## **EXHIBIT A-6**

### **ADDENDA**

**NORTHERN KENTUCKY WATER DISTRICT  
TAYLOR MILL TREATMENT PLANT  
TMTP UPGRADES & IMPROVEMENTS  
Project No. WX21117018**

**ADDENDUM NO. 1**

**ATTACHMENT 2-E**  
**REVISED SHEET P4.3**

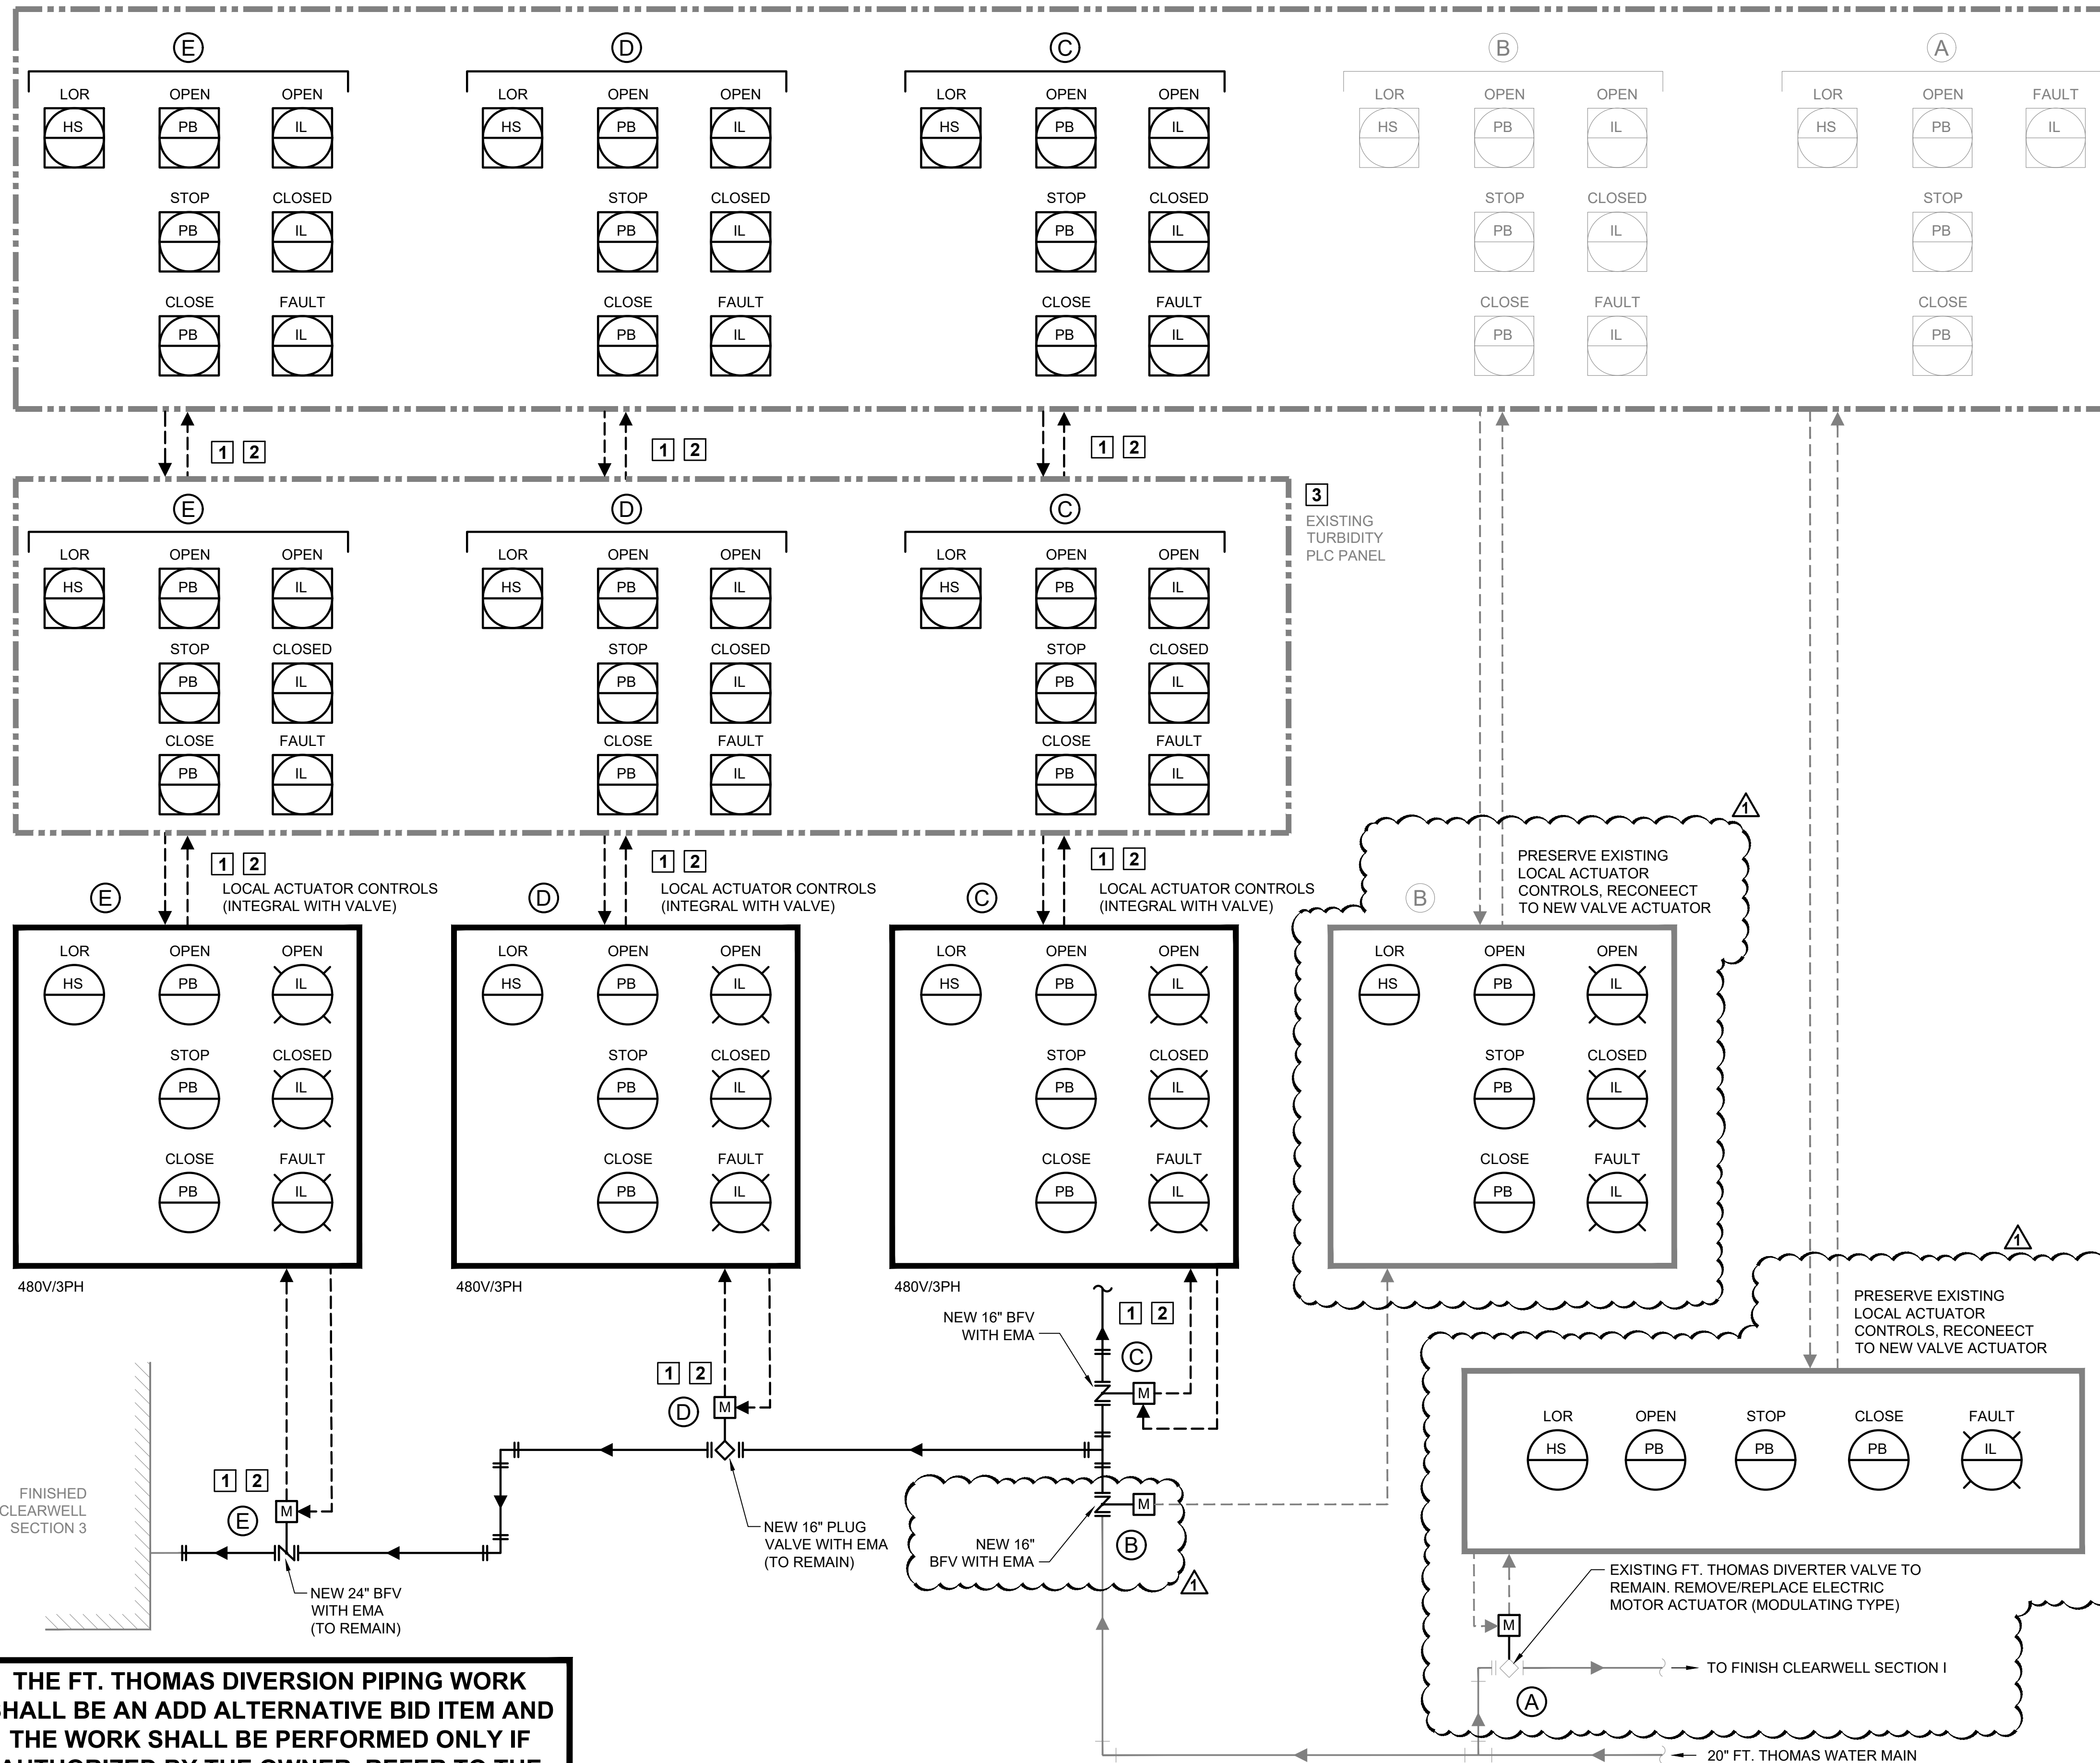
- Delete in its entirety
- Insert new Sheet P3.1, Add Alternative Bid Item: Ft. Thomas Diversion Piping Sections, provided in Attachment 2-D.
- Item 11. Sheet P4.3, Add Alternative Bid Item: Ft. Thomas Diversion Piping P&ID

- Delete in its entirety
- Insert new Sheet P4.3, Add Alternative Bid Item: Ft. Thomas Diversion Piping P&ID, provided in Attachment 2-E.
- Item 12. Sheet S0.1, General Notes, Repair Schedule, Repair 'B', Bid Quantity
